DEPARTMENT OF THE ARMY
CORPS OF ENGINEERS, OMAHA DISTRICT
215 NORTH 17TH STREET
OMAHA, NEBRASKA 68102-4978

Enclosed for your information are three (3) copies of the Final Pre-Design Field Investigation Report for the NL Industries/Taracorp Superfund Site, Granite City, Illinois.

This is the final comment letter regarding the draft PDRI report. I am available to participate in a meeting or conference call to discuss comments #2 and #11 and any other comments you may wish to discuss. Please contact me at (312) 886-4742 to arrange a meeting/conference call.

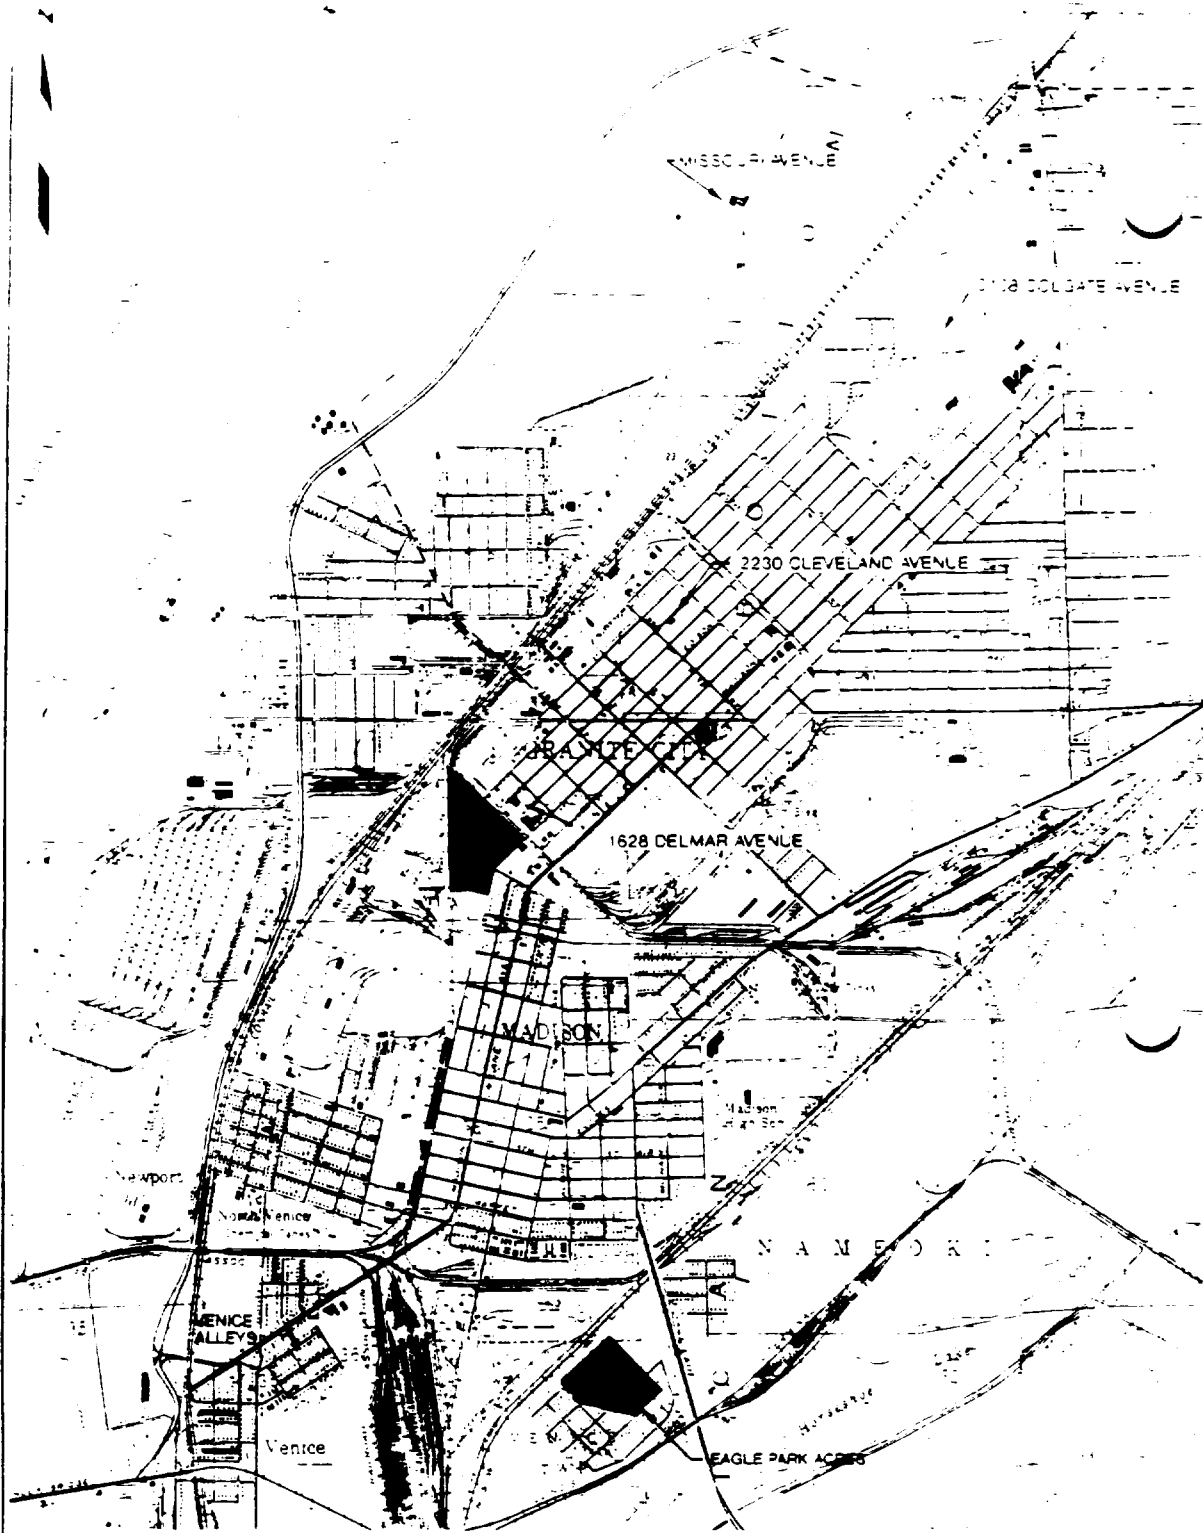
13. Figure 3 - Sand Road is mislabelled on this Figure. "Chain of Rocks Road" is east-west road that is currently labelled as "Sand Road" on the figure. Sand Road is actually the north-south road that is approximately one inch from the right border of the figure.
